Considerations for Clause 98.8.2.2 Impedance Balance

IEEE P802.3bq 40GBASE-T Task Force

IEEE P802.3bq, Atlanta GA, January 2015

Figure 98-42—MDI impedance balance test circuit

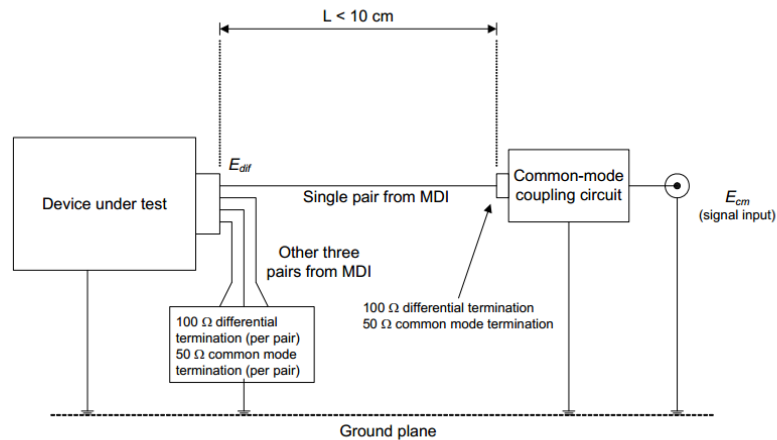
The impedance balance is measured with a common-mode coupling circuit presenting a differential termination of 100 Ω and a common-mode termination of 50 Ω to the MDI pair under test as shown in Figure 98–42. The return loss for both differential and common terminations in the common-mode coupling circuit should be greater than 20 dB from 10 MHz to 2000 MHz. The insertion loss IL_{cal} (in dB) of the common-mode coupling circuit can be measured with the test circuit shown in Figure 98–43.	28 29 30 31 32 33
NOTE 1—Triggered averaging can be used to separate the component due to the applied common-mode sine wave from the transmitted data component.	34 35
NOTE 2—The imbalance of the test equipment should be insignificant relative to the balance requirements.	36 37
The impedance balance may also be measured with a mixed mode four port network analyzer capable of measuring the common-mode voltage and differential mode voltage of a balanced port. Impedance balance is the S parameter measurement of S_{cd11} in dB at the MDI where two ports of the four port network analyzer are connected between two MDI contacts used by a duplex link channel and these two ports are configured as a single balanced port. For this test the PHY ground is connected to the network analyzer ground. The other two ports of the network analyzer are unconnected. The network analyzer should be capable of measuring S_{cd11} to at least –60 dB and should use a differential input impedance of 100 Ω and a common-mode impedance of 75 Ω .	38 39 40 41 42 43 44 45 46

During the test the PHY is connected to the MDI as in normal operation, but with the transmitter output disabled.	47 48 49 50

“The impedance balance is defined as the S parameter measurement of Sdc11 in dB at the MDI.

The impedance balance may be measured with a mixed mode four port network analyzer capable of measuring the common-mode voltage and differential mode voltage of a balanced port.

Impedance balance is the S parameter measurement of Sdc11 in dB at the MDI where two ports of the four port network analyzer are connected between two MDI contacts used by a duplex link channel and these two ports are configured as a single balanced port.

For this test, the PHY ground is connected to the network analyzer ground.

The other two ports of the network analyzer are unconnected.

The network analyzer should be capable of measuring Sdc11 to at least –60 dB and should use a differential input impedance of 100Ω and a common-mode impedance of 75Ω.

During the test the PHY is connected to the MDI as in normal operation.”

MDI Impedance Balance limit (P802.3bq D1.1.1 Equation 98-53)

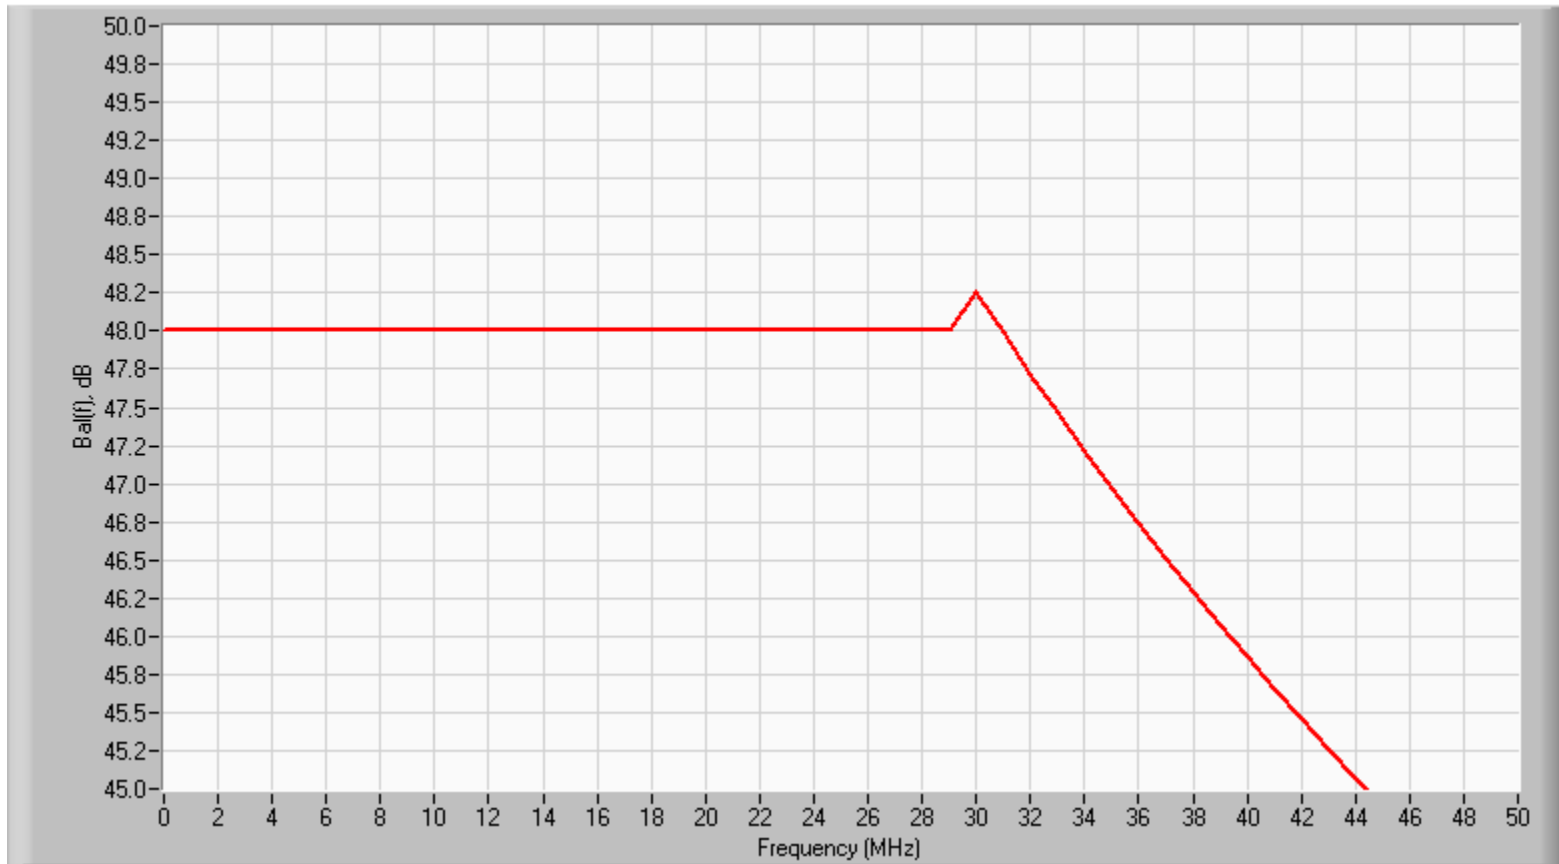
Slight Discontinuity in Equation 98-53
